Subject: BAR Action - 416-418 West Main Street - june 20, 2017

CITY OF CHARLOTTESVILLE BOARD OF ARCHITECTURAL REVIEW STAFF REPORT June 20, 2017

BAR 17-06-09
416-418 West Main Street
Tax Parcel 290012000
Main Street West, LLC, Owner/ Greg Jackson., Applicant
Replace Roof

JANUARY 2017 DENIAL

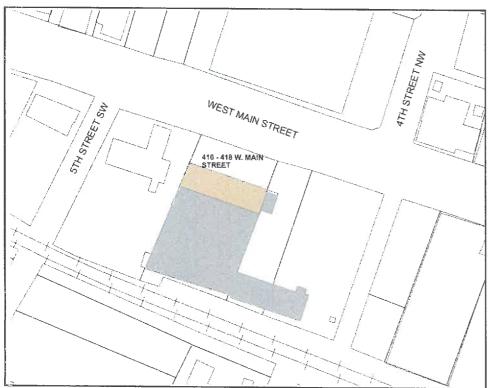
<u>January 17, 2017</u> –At the applicant's request for a decision rather than deferral, despite the BAR's encouragement for the applicant to request a deferral, the BAR denied (6-0) the applicant's request for a new roof addition, specifically because the hip roof was not compatible with the historic building and the historic district. (Drawing attached)
